T10/06-470 revision 0

Date: October 27, 2006

From: George Penokie (IBM)

Subject: SAS-2: Transport layer read data flowchart

Figure 1 — Representation of transport layer (i.e., ST_TTS1 and ST_TTS3) read data operation

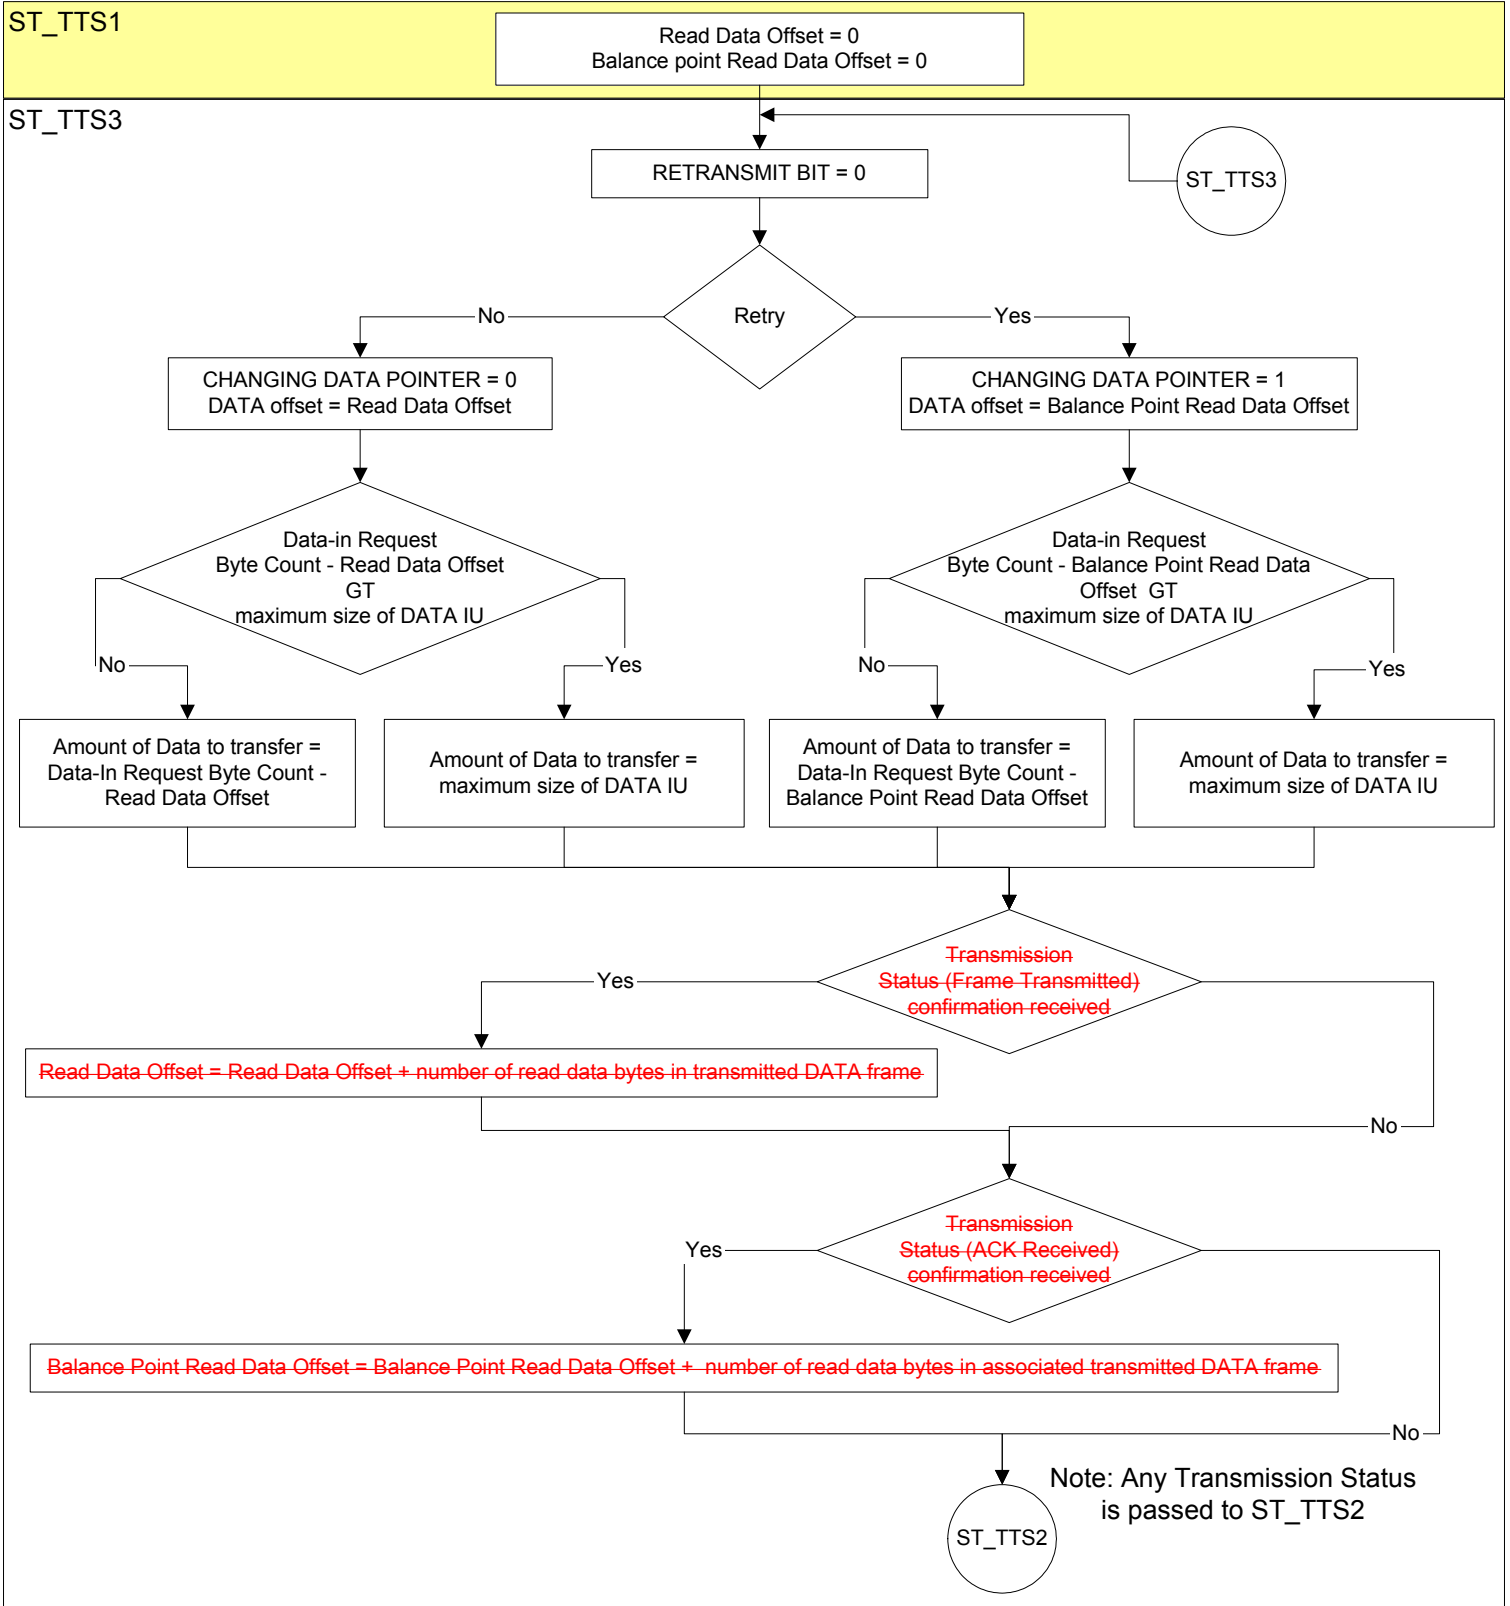
In the process of converting the words that are currently in SAS-2 there were no errors found, however, some of the wording may be somewhat unclear. Also, it was discovered that one of the conditions described in ST_TTS3 can never happen and another is already checked in ST_TTS2 so this proposal is recommending that they be deleted. See below the flowcharts for the suggested changes.

~~If a confirmation of Transmission Status (Frame Transmitted) is received, then this state shall set the Read Data Offset state machine variable to the current read data offset plus the number of read data bytes in the transmitted read DATA frame.~~

~~If a Transmission Status (ACK Received) confirmation is received, and the Transmit Frame request was for a read DATA frame, then this state shall set the Balance Point Read Data Offset state machine variable to the current balance point read data offset plus the number of read data bytes transmitted in the read DATA frame associated with Transmission Status (ACK Received) confirmation.~~
